## TRUCK, TRANSPORTER, FLOATING BRIDGE, MC3, W/WINCH, MACK, LAUNCH AND RECOVERY VEHICLE (LRV) NSN 2320-66-131-6653

### LRV ROOF RACK

## MODIFICATION INSTRUCTION

Figure 1 - Photograph of Cut-Out in Roof Rack

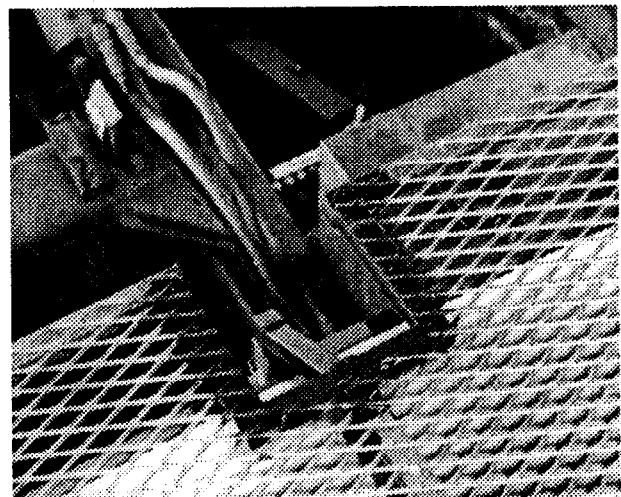
1. EMEI Vehicle G 787-1 detailed the fitting of a roof rack and amber flashing light to the LRV. This instruction details a minor modification to the roof rack to stop interference between it and the winch rope.
2. **Associated Publications.** Reference may be necessary to the latest issue of the following documents:
  - a. EMEI Workshop A 850 - Modifications, Trial Modifications and Local Modifications to Equipment;
  - b. EMEI Workshop A 851 - Recording Modifications to Equipment - Use of Modification Record Plates and Documentary Requirements;
  - c. Engineering Change Order (ECO) No AEM 5011; and
  - d. EMEI Vehicle G 787-1 - Fitting of Roof Rack.
3. **Authority.** ECO No AEM 5011 is the authority to carry out this modification.

10. The procedure to carry out the modification to the roof rack is as follows:
  - a. Remove the existing amber light assembly off the roof rack.
  - b. Remove roof rack off cab.
  - c. Modify roof rack as detailed in Figures 1 and 2, using Items 1 and 2 from Table 1, by cutting out a section and welding in the framework to support the mesh.
